Subject: Applicant's Response to Data Requests, Set 2A, #159 (11-AFC-04)

APPLICANT'S RESPONSE TO DATA REQUEST #159

Technical Area: Biological Resources

**APPLICATION FOR CERTIFICATION
FOR THE *RIO MESA SOLAR*
*ELECTRIC GENERATING FACILITY***

Figure 1

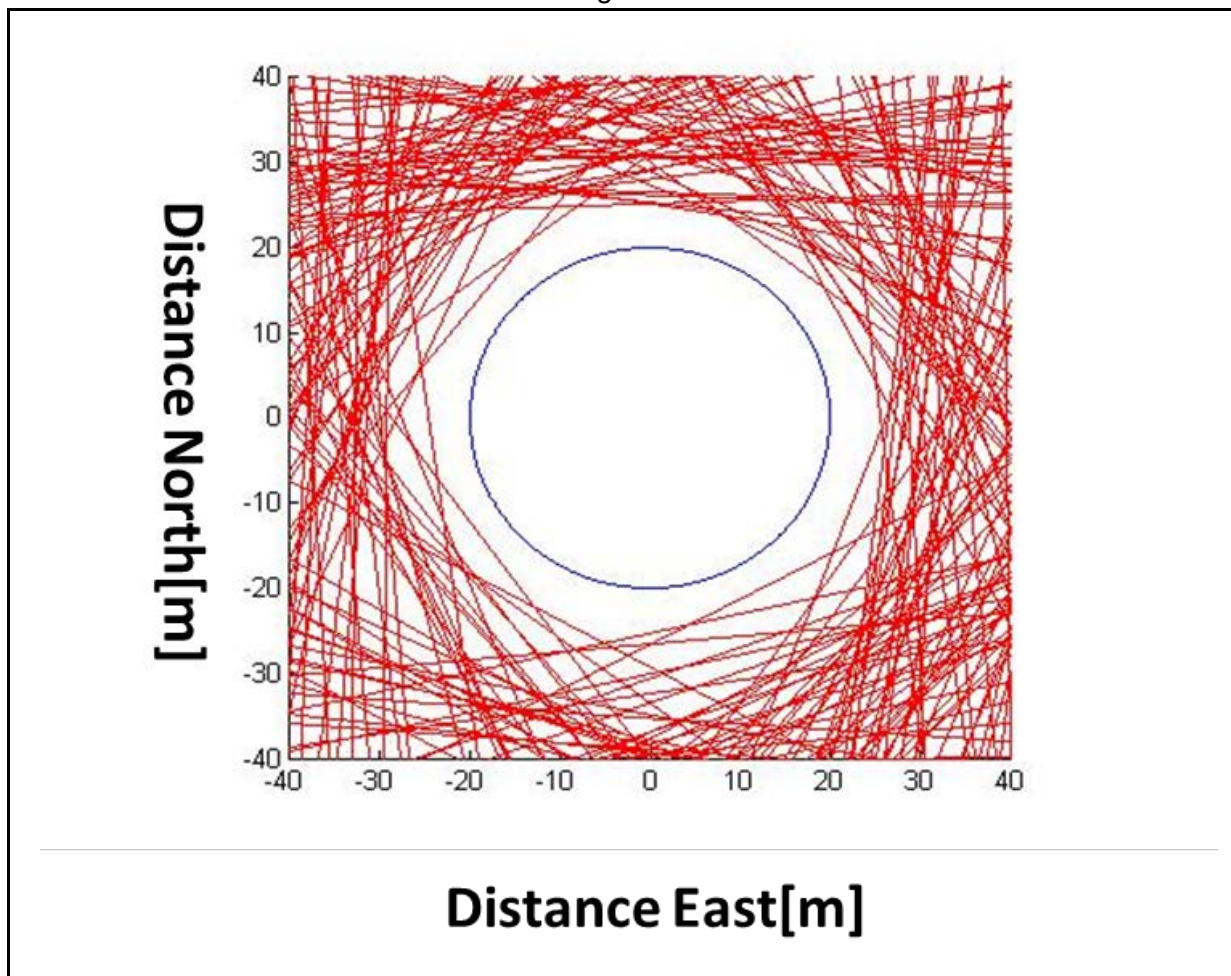
159. Please provide a three-dimensional graphical model of the southern 250 MW (net) facility proposed for Rio Mesa SEGF under full-load, partial-load and full standby status, illustrating the composite effect of convective heat and radiant flux. The modeled convective heat should include elevated temperature of the receiver tower and heliostat surfaces on surrounding air. The modeled radiant flux must include all radiant energy, including (1) ambient solar energy; (2) energy reflected and/or radiated from heliostats to the receiver tower, the standby locations, and the surrounding air; and (3) energy reflected and/or radiated from the receiver tower

Heliostats in the standby mode are modeled to be aiming to a torus-like or halo shape which surrounds the receiver, as illustrated in Figure 1 below which shows looking from above the SRSG, the solar ray paths of the center of heliostat beams around the SRSG (blue circle).

Figure 2: Full load with 0% stand-by

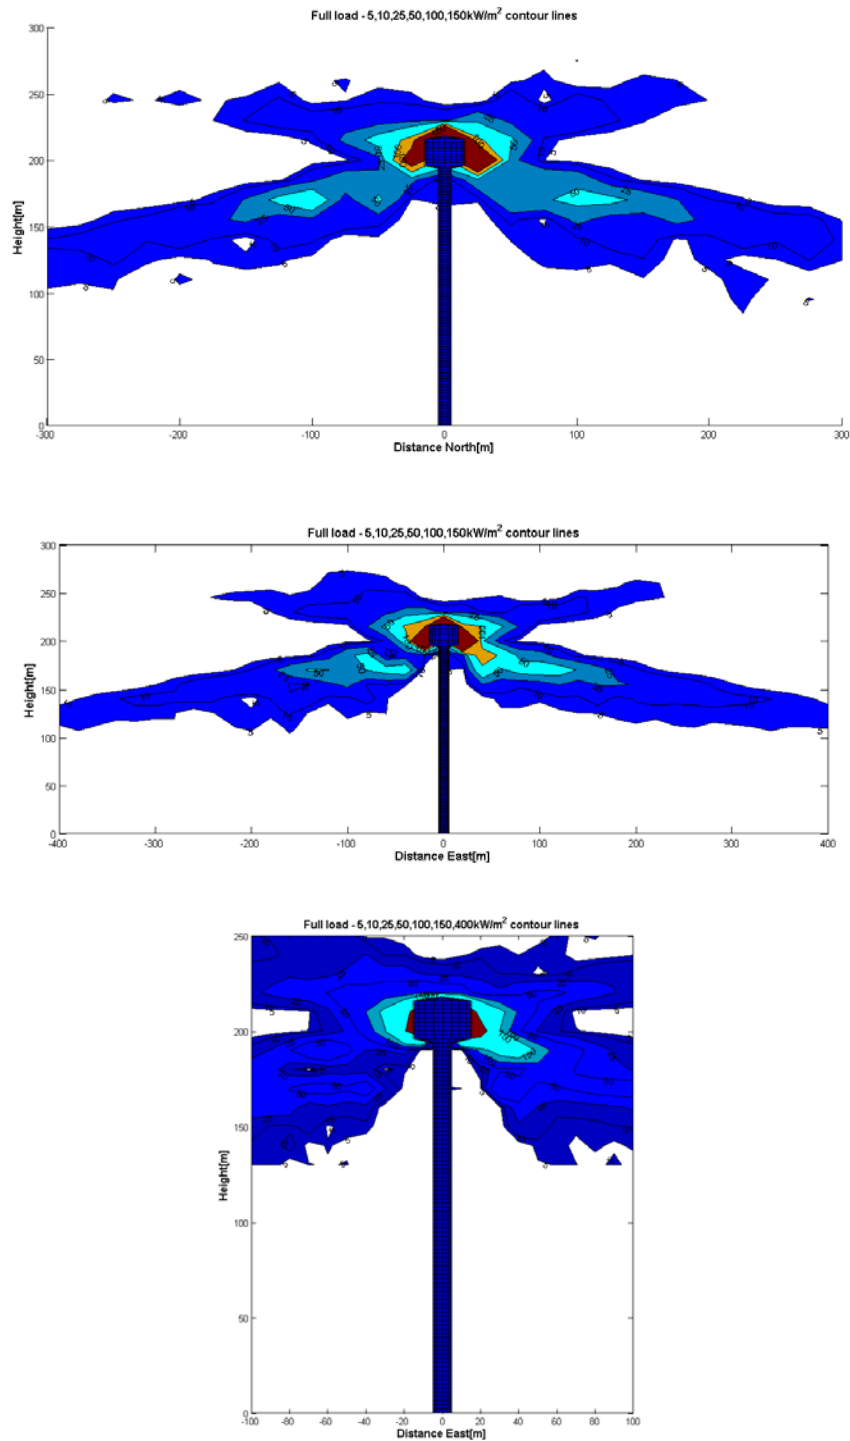
- a. The partial-load model should be based on typical load level expected during spring and fall midday operating conditions.
- b. The radiant flux model should show the density conditions as contours at 2.5 kW/m², 10 kW/m², 25 kW/m², 50 kW/m² and 150 kW/m².

As can be seen in the profile views in Figure 2 below, flux intensity higher than 5kW/m^2 starts at approximately 100m in elevation and at a horizontal distance of approximately 400m from the tower center. Flux intensity of 50kW/m^2 starts at an elevation of approximately 160m and extends 150m from the tower center. Flux above 150kW/m^2 starts at an elevation of approximately 180m and extends out only 50m from the tower center (40m from the SRS face).

The flux intensity due to spillage (radiation that misses the receiver) is relatively low, and has been computed to be in the range of only $5\text{-}10\text{kW/m}^2$, and is limited to a maximum height of 280m (920ft) above ground level. Although not shown on Figure 2, flux of 2.5kW/m^2 is not expected to exceed 300m in height above the ground.

Figure 3: Plan View of Flux at Full load with 0% standby over RMS 1 Solar Field

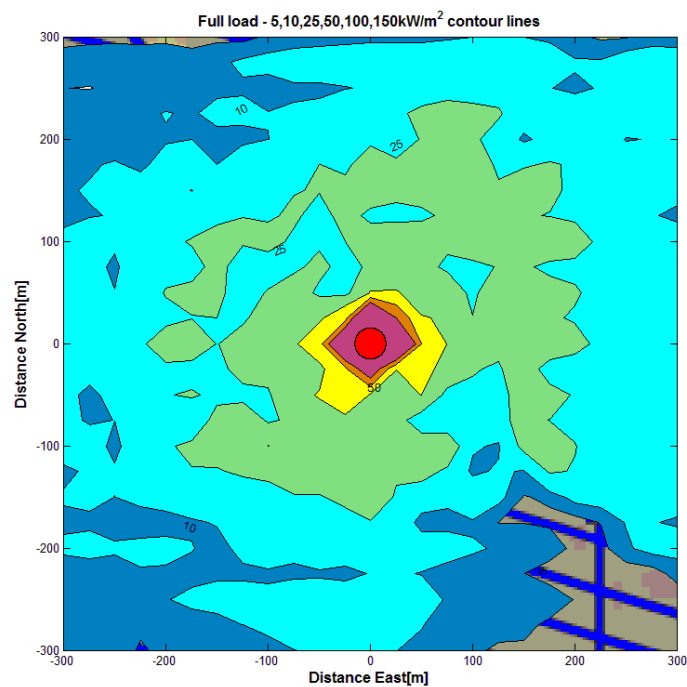
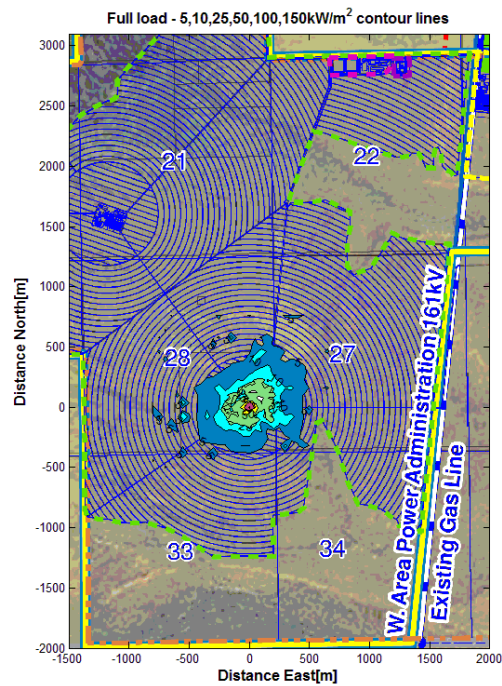
- f. The boundaries of the analysis should identify the location of the microphyll woodland habitat that would be retained within the mirror field in Section 22.

Part f. Complied, See Figure 3

The total air space volume with a flux maximal quantifier of greater than 5kW/m^2 is approximately 0.88% (Figure 3). The diametrical span of this flux level is approximately 400m from the tower center and the volume is approx. $23 \times 10^6 \text{ m}^3$ while the total air volume over the solar field is approximately $2.6 \times 10^9 \text{ m}^3$ (one unit). As shown in the images above, the volume occupied by flux greater than 10kW/m^2 and 50kW/m^2 is much smaller and is less than 0.4% and 0.04% from the total air volume of the solar field respectively.
